Lanark Road – Community Council Engagement

This document sets out officer's proposals for revisions to the Spaces for People scheme on Lanark Road which aim to achieve these mitigations.

Spylaw Park Existing

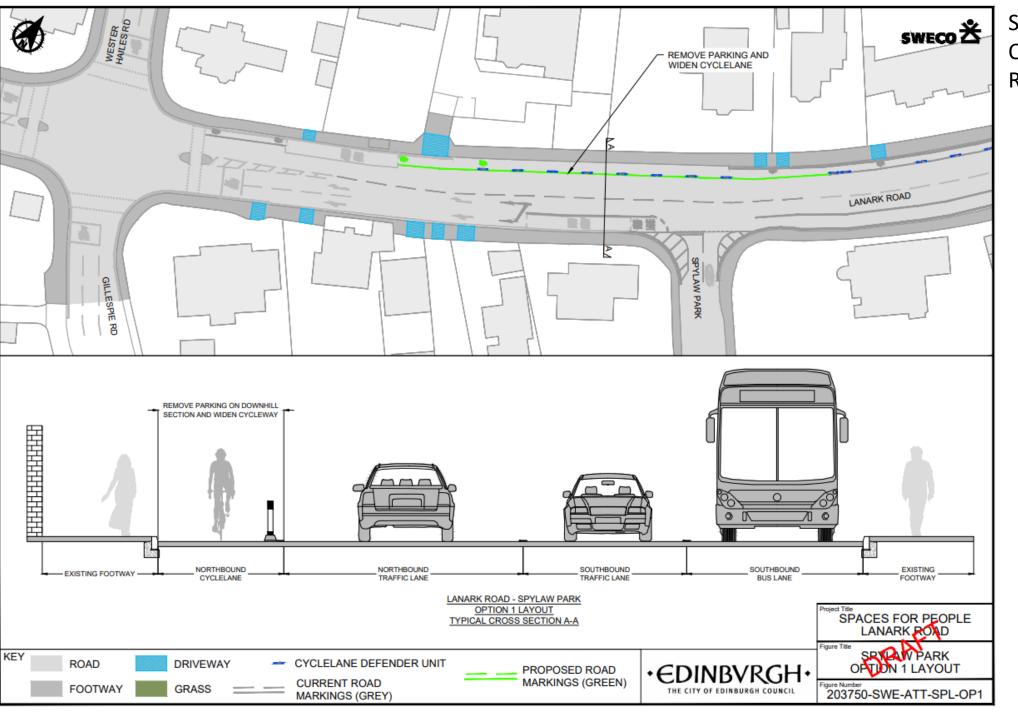
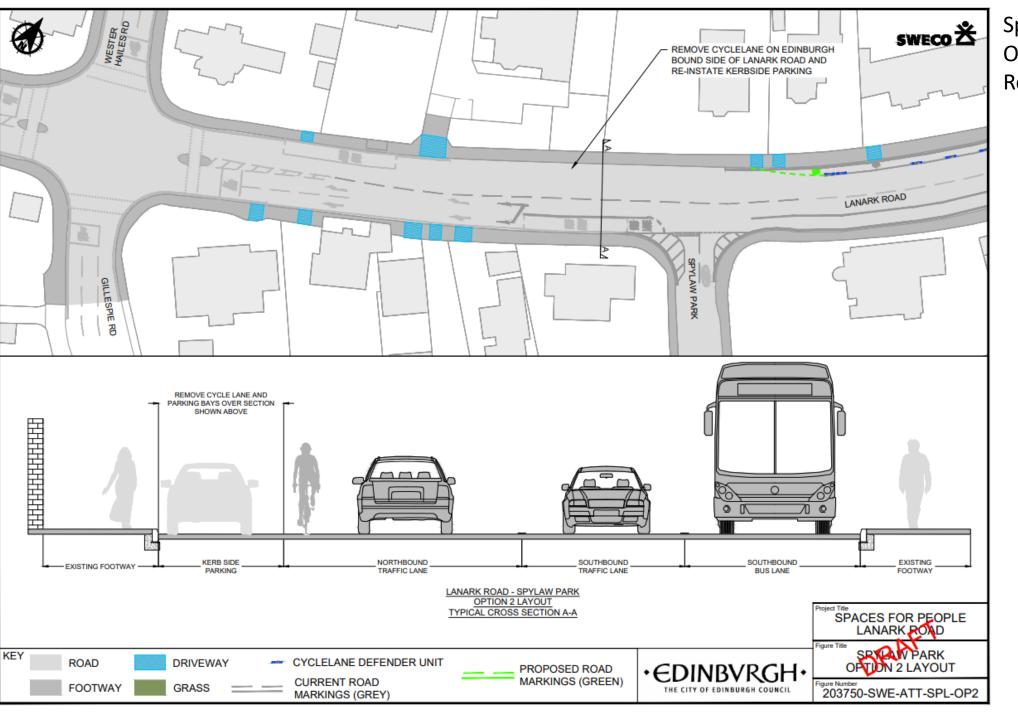
We are aware of concerns regarding conflict between parents accessing Cranley Nursery and passing cyclists at this location.

Due to it's location this section of cycleway is also likely to be less heavily used, and less beneficial to users than the remainder of the corridor.

There are two proposed options at this location.

- 1. Remove the Parking
- 2. Remove the cycleway

As it is possible to leave the Water of Leith path, and join Lanark Road at Spylaw Bank Road, the cycleway at this location serves fewer journeys than the rest of the route.

In addition, anyone cycling on this section is likely to have cycled in from Lanark Road West and will thus likely be capable of cycling around the parking area, before accessing the cycleway further along the road.

For these reasons it is considered a reasonable option to remove the cycleway at this location. Options are shown on the following pages.

Spylaw Park
Option 1 –
Remove Parking

Spylaw Park
Option 2 –
Remove Cycleway

Dovecot Park Existing

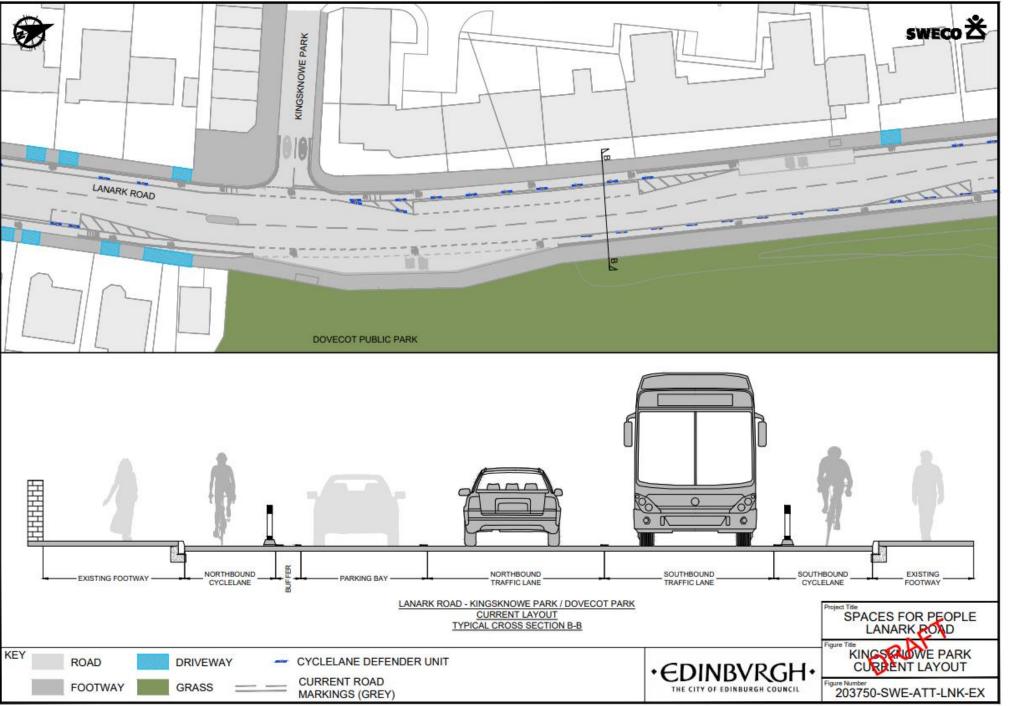
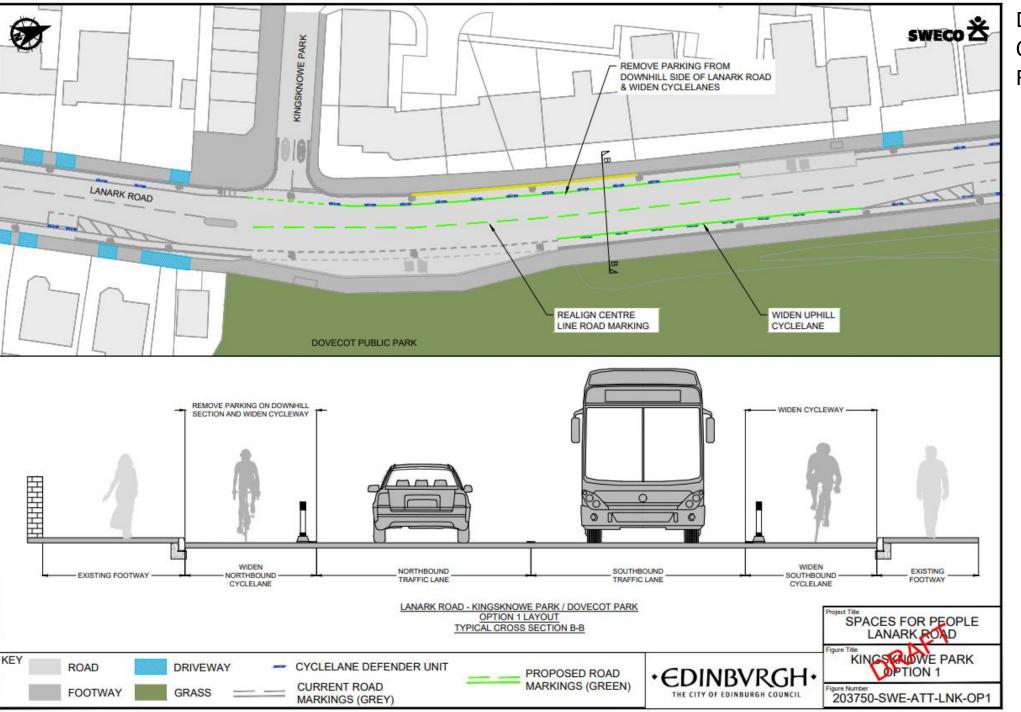
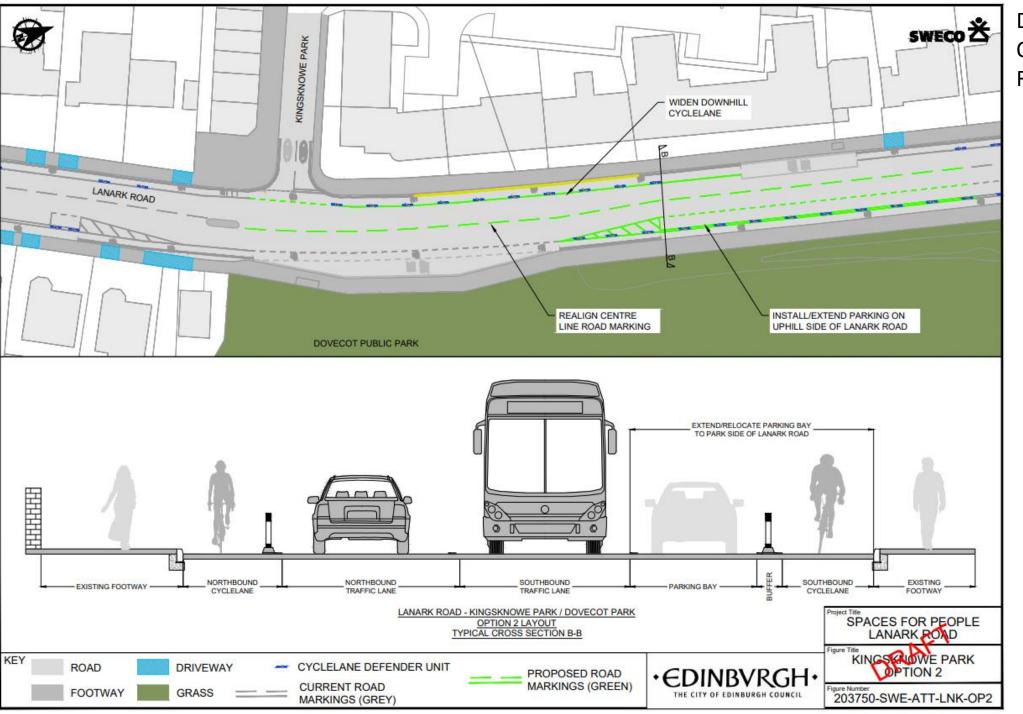
We are aware of conflict at this location between people accessing the parked cars and passing cyclists, including reports of near misses and collisions.

There are two options at this location:

- 1. Remove the parking
- 2. Relocate the parking to the opposite side of the road
 - 1. (Relocating the parking results in a net increase in the number of spaces)

Dovecot Park
Option 1 –
Remove Parking

Dovecot Park
Option 2 –
Relocate Parking

Example of
Proposed
Markings at all
Parking Areas

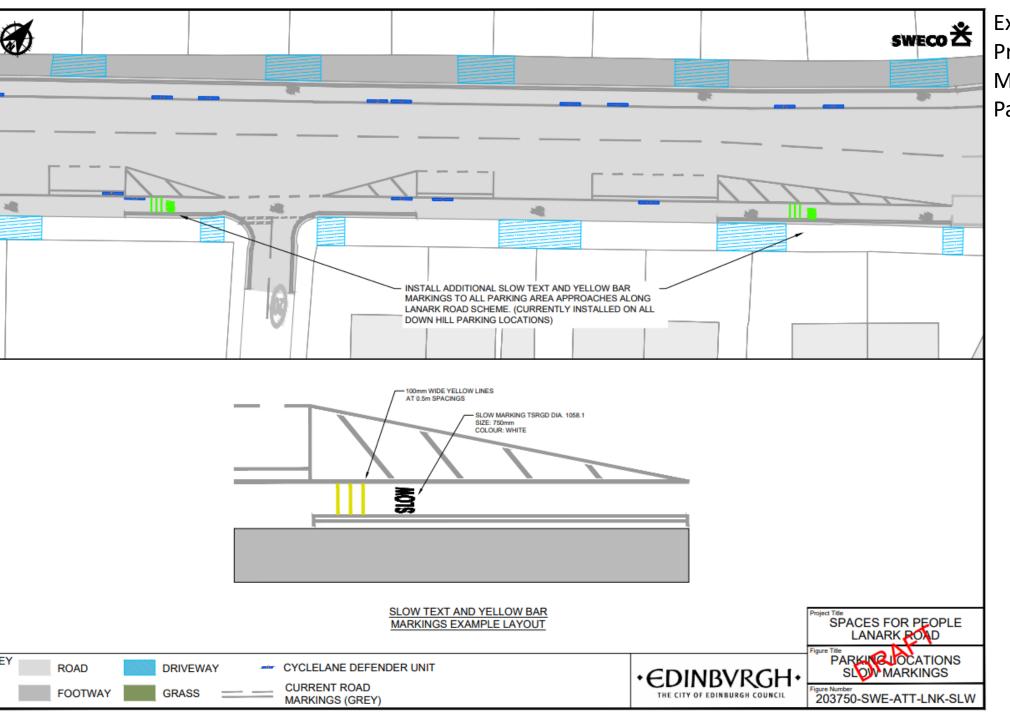
At all remaining parking areas the risk of conflict between people cycling and people accessing parked cars is mitigated by the topography. Nonetheless, it is proposed to introduce further markings to encourage people cycling to keep to an appropriate speed while passing parking areas. An example arrangement is shown overleaf.
